**Notice of Meeting for the  
Historic and Architectural Review Commission  
of the City of Georgetown  
September 10, 2020 at 6:00 PM  
at Teleconference**

# Planning Department Staff Report

File Number: *2020-43-COA*

Project Name: *1257 S. Church Screened Porch*  
Applicant: *Michael Huston*  
Property Owner: *Michael & Mary Huston*  
Property Address: *1257 S. Church Street*  
Legal Description: *Lot 18, Block I of the Code Addition*  
Historic Overlay: *Old Town Overlay District*  
Case History: *N/A*

Fig. 5 Schematic (not to scale) of porch showing areas to be screened. A) Entry door to screened area of porch; B) Screen facing S. Church St.; C) Screen facing S 15th St.

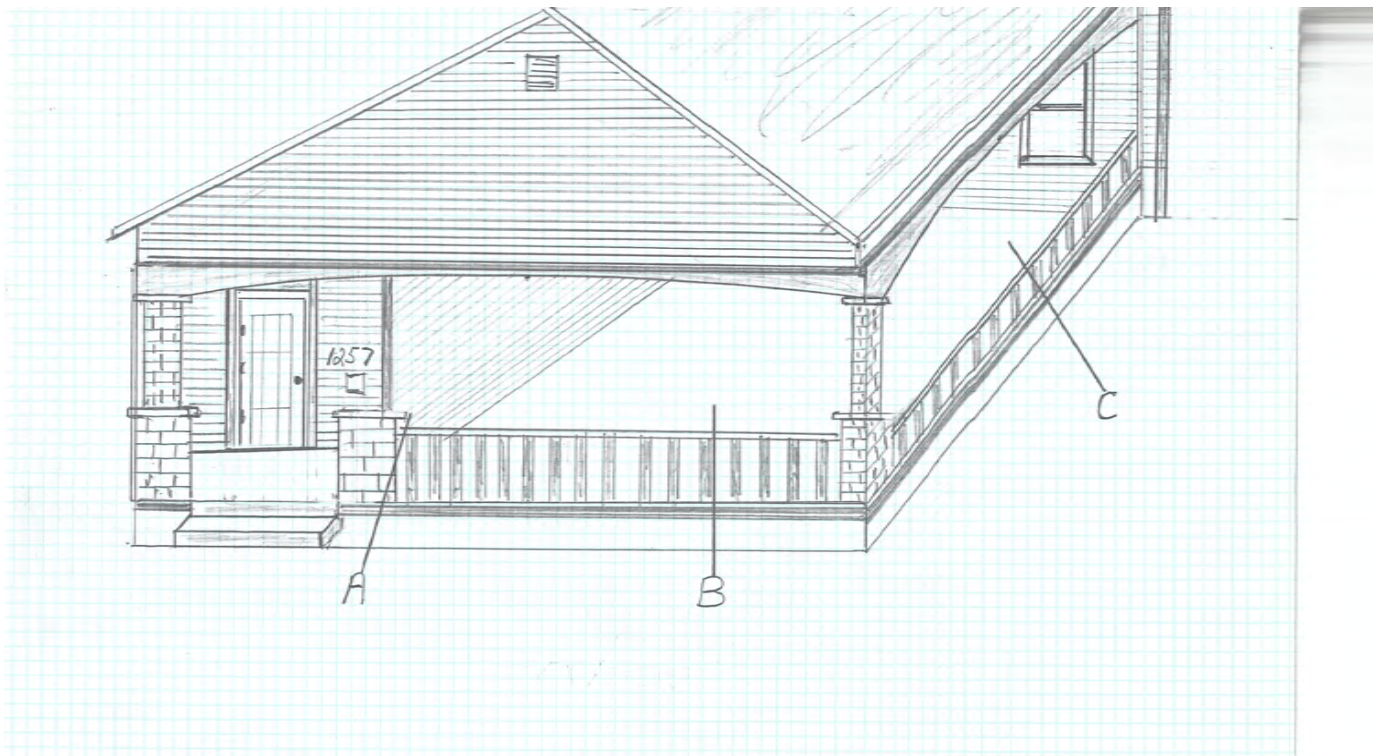
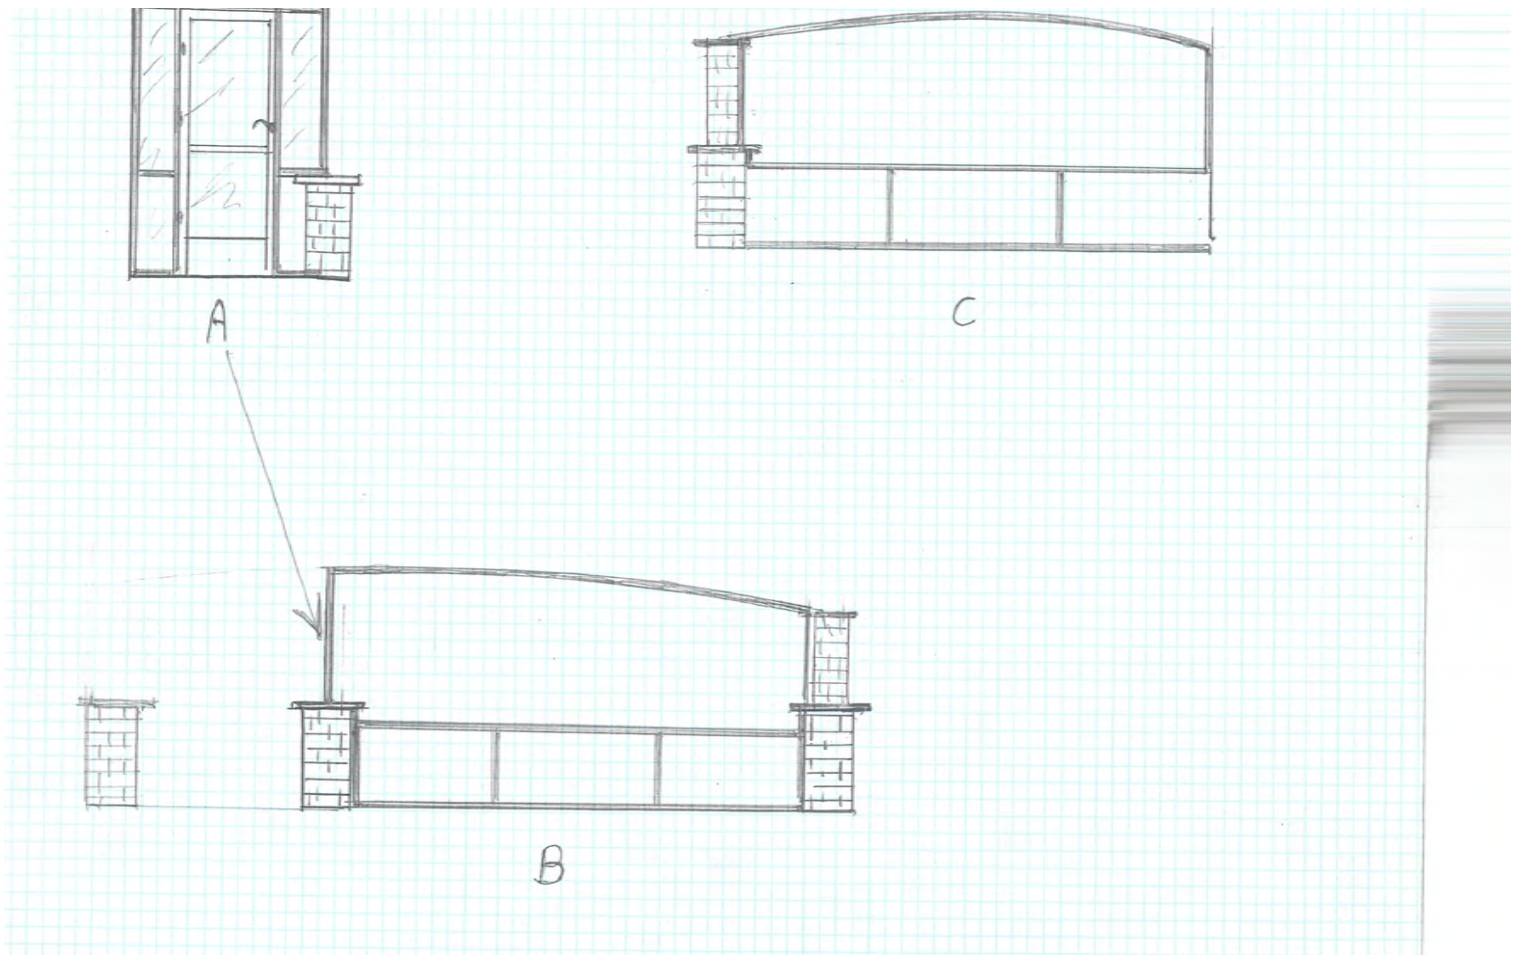
The applicant is requesting HARC approval of a request to enclose the front porch with screening material to protect against mosquitoes in warmer months. The screening material is proposed to be installed with minimal disturbance to the historic material, and the screens would be installed within thin frames attached to the porch to minimize the visual impacts from the street. As the front porch is asymmetrical with the front door to the left of the porch as viewed from S. Church Street, the screened area would be limited to the portion with porch railing, and not include screening across the area in front of the front door so that the front door remains fully visible from the street.

The medium priority historic structure has a large, west-facing front porch that is original to the design of the house, which is Craftsman in style with low roof slopes, stone columns at the front porch, exposed rafters under the roof eaves and an asymmetrical front façade. The low height of the beam across the stone porch columns and the presence of landscaping provide for a less obtrusive condition for the installation of screening as seen from the street.

GUIDELINES	FINDINGS
<b>CHAPTER 6 – DESIGN GUIDELINES FOR INDIVIDUAL BUILDING ELEMENTS</b>	
<b>6.25 Maintain an historic porch and its detailing.</b> <ul style="list-style-type: none"><li>✓ Do not remove original details from a porch. These include the columns, balustrade, and any decorative brackets that may exist.</li><li>✓ Maintain the existing location, shape, details, and columns of the porch.</li></ul>	<b>Complies</b>  The proposed screening installation would retain all of the existing porch elements in place and is proposed to attach the bronzed aluminum framework for the screens inside of the railing.

<p><b>6.26 Avoid enclosing an historic front porch with opaque materials.</b></p> <ul style="list-style-type: none"><li>✓ Enclosing a porch with opaque materials that destroy the openness and transparency of the porch is inappropriate.</li><li>✓ If historic porches that have been enclosed in the past are proposed to be remodeled or altered, they should be restored to their appearance during the period of significance, unless the enclosure, by nature of its age, architectural significance, or other special circumstance, has achieved historic significance of its own.</li></ul>	<p><b>Complies</b></p> <p>The proposed screens are transparent and are proposed to be installed with bronzed aluminum framework attached inside of the railing so that the view of the railing will be unobstructed.</p>

GUIDELINES	FINDINGS
<b>CHAPTER 6 – DESIGN GUIDELINES FOR INDIVIDUAL BUILDING ELEMENTS</b>	
✓ When a porch is enclosed or screened, it shall be done with a clear transparent material. This material should be placed behind porch columns.

Based on the findings listed above, staff recommends *APPROVAL* of the request.
